SERVICE INFORMATION BULLETIN

APPLICABILITY: 2019MY Ascent NUMBER: 02-183-19

SUBJECT: Turbocharger Stay Bracket Bolt DATE: 09/26/19

Tightening Sequence

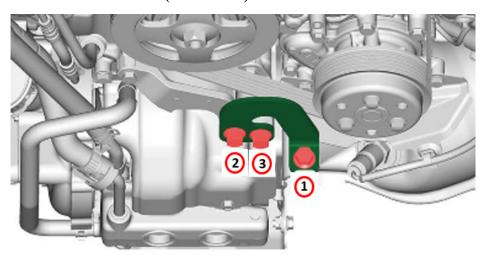
This Service Information Bulletin clarifies a bolt tightening sequence procedure for the three (3) turbocharger stay bracket mounting bolts. Torsional stress may remain in the stay bracket if the tightening sequence is not followed. The applicable Service Manual will be updated with this information soon.

The illustration below shows the location of the bolts and the tightening sequence. The torque specification for all 3 bolts is 65 Nm (47.9 ft. lbs.).
